Re: Proposed Single Family Dwelling, 907 Omagaki Way, Lot # 263 Pathways, City of Ottawa, Kollaard Associates File # 220022

With regard to structural issues only, Kollaard Associates has reviewed the following drawings:

SK-1

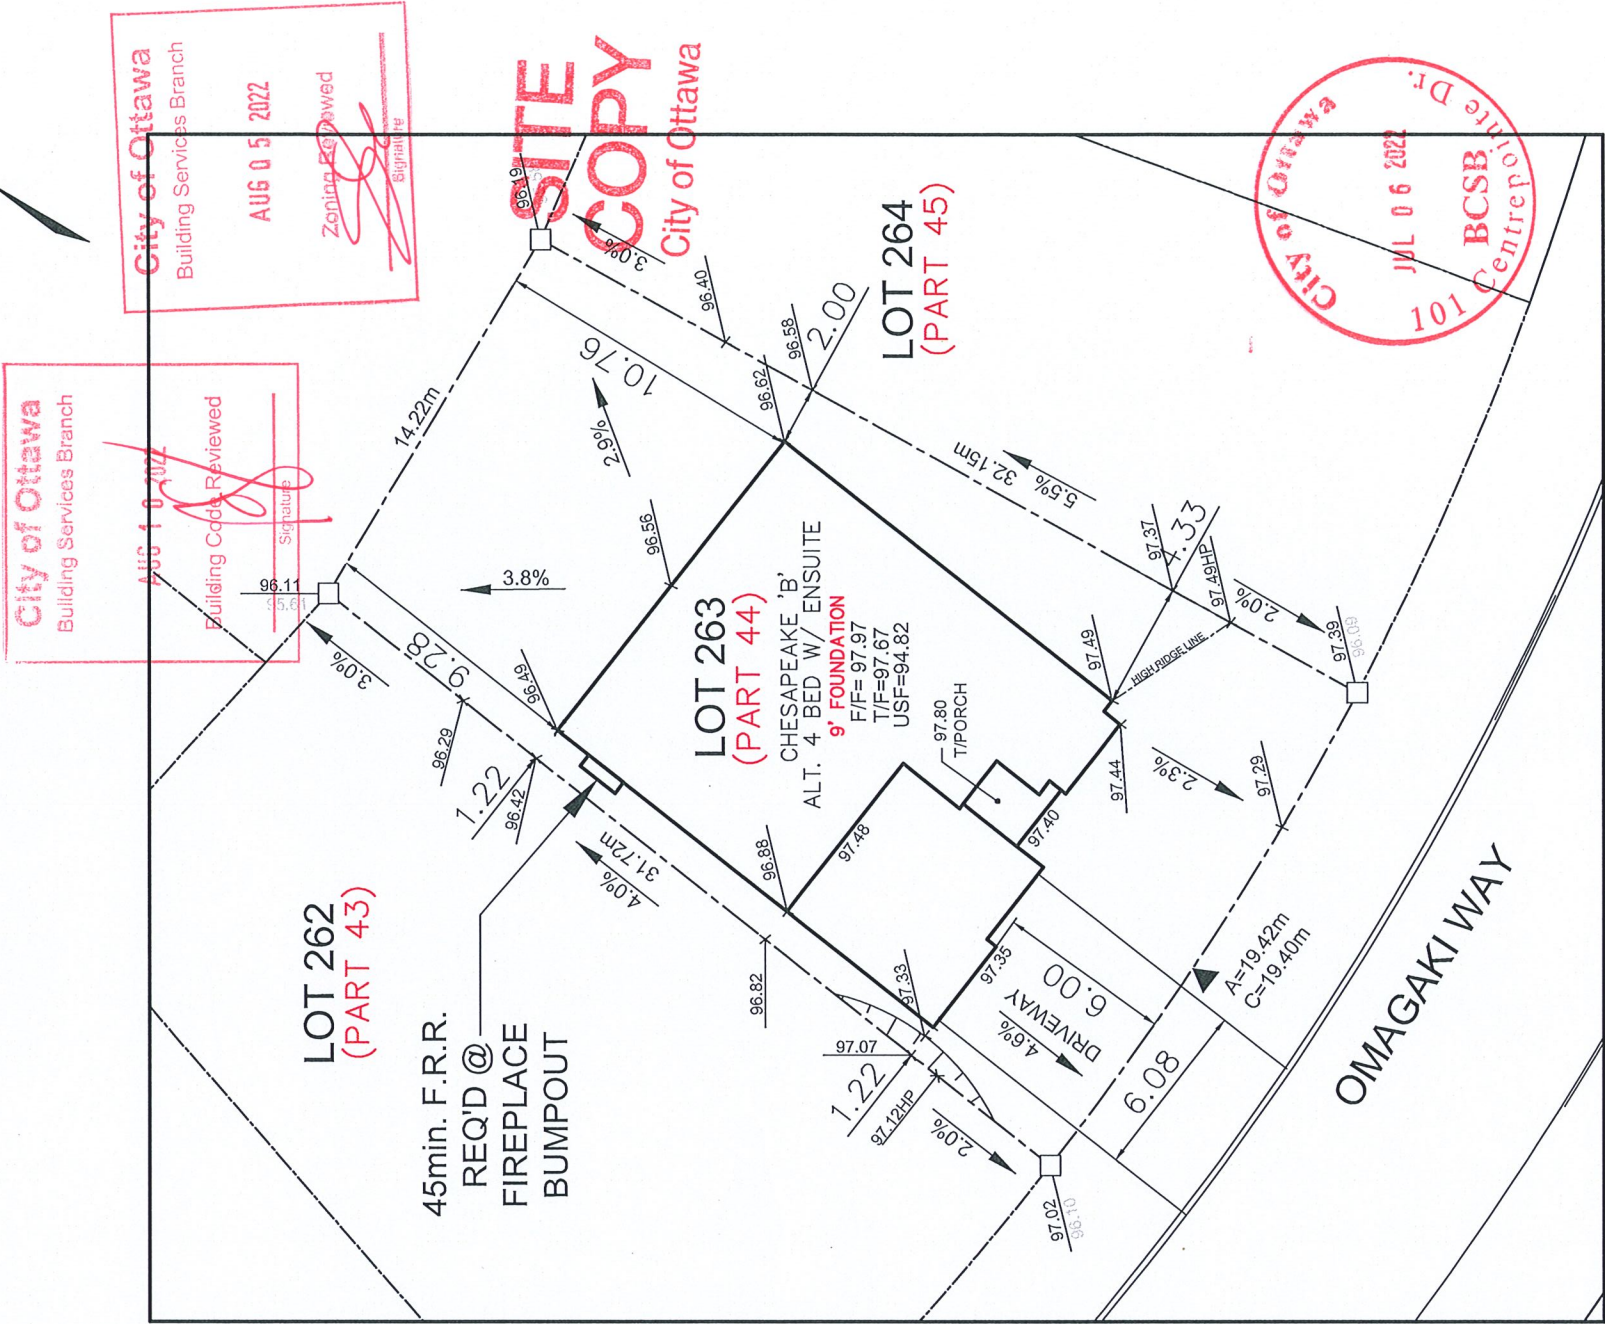
15. The details for the rear bracket supporting the landing are designed and approved by others (Estructura Inc. Dwg. # SK-1, Stamp Date: December 6, 2019).

LOT 263 SITE/GRADING PLAN PATHWAYS PHASE 2

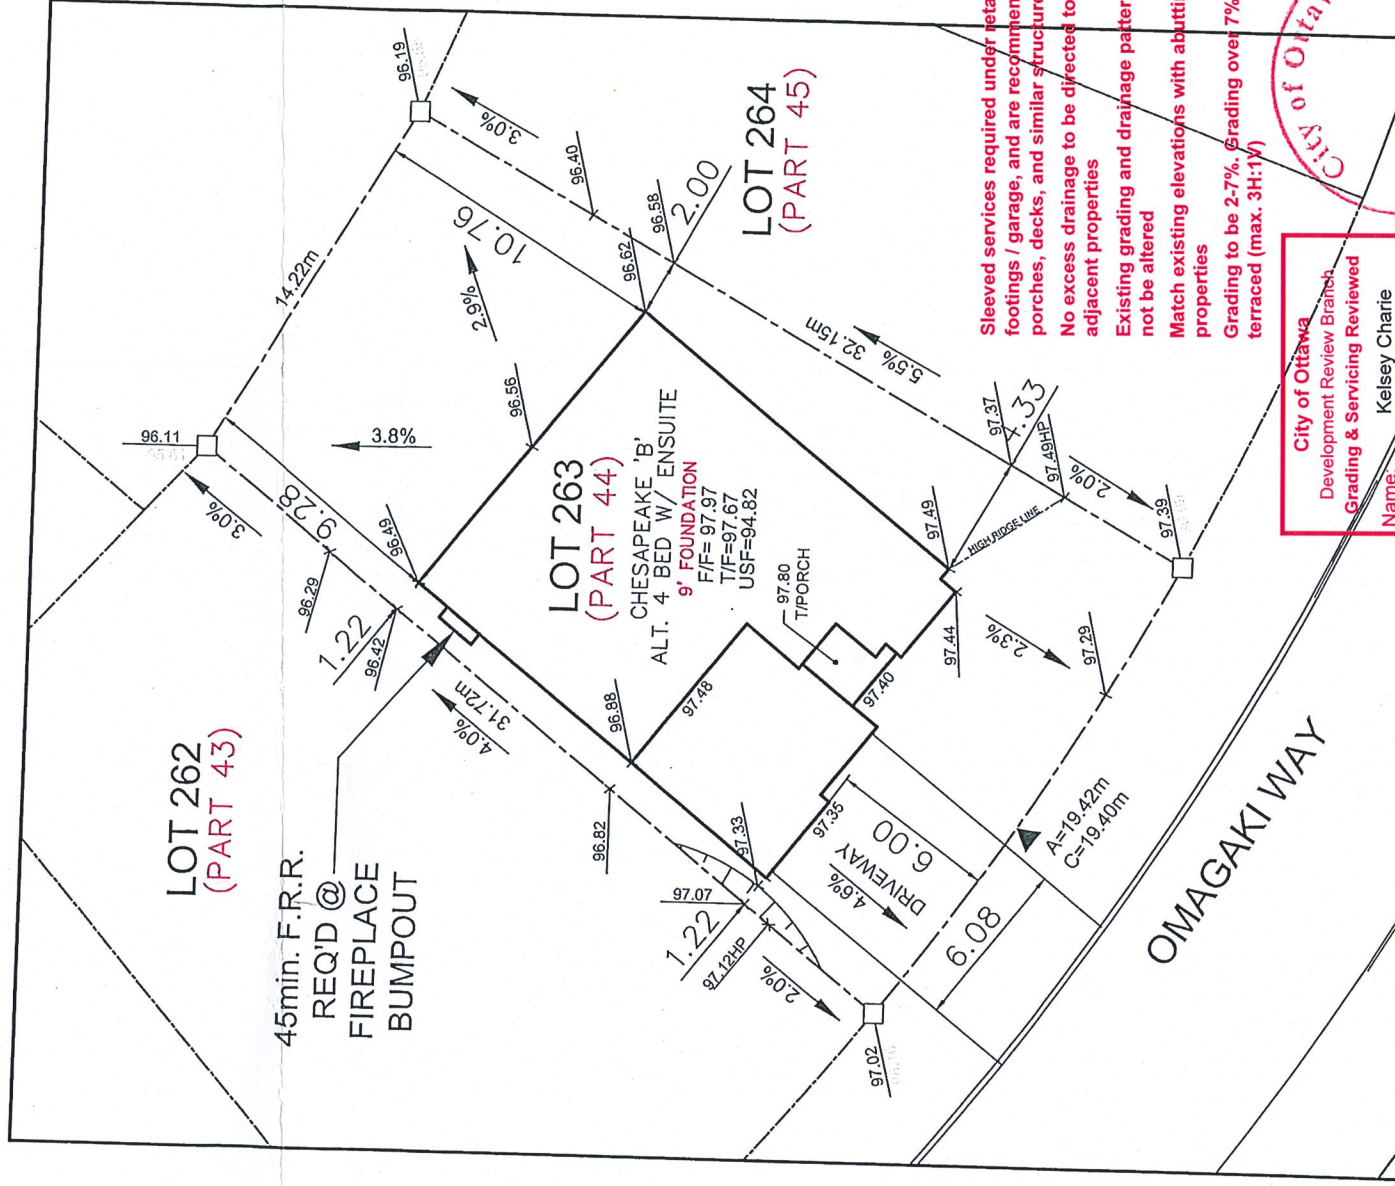
12. The proposed grading plan (Phoenix Homes, 907 Omagaki Way) shows a maximum finished grade around the dwelling (including interior of garage) at the as 97.49 metres, which is 2.38 metres above the basement slab elevation. It is the understanding of Kollaard Associates that 2-15M bars are installed at the top and bottom of the foundation walls and bent around the corners. It is the opinion of Kollaard Associates that the 8" thick foundation walls with 2-15M bars at the top and bottom are adequate to withstand the lateral earth pressures as the grade difference between the garage slab (and exterior grade) and basement slab is 0.09 metres greater than the 2.30 metres specified in 2012 OBC Table 9.15.4.2.A.
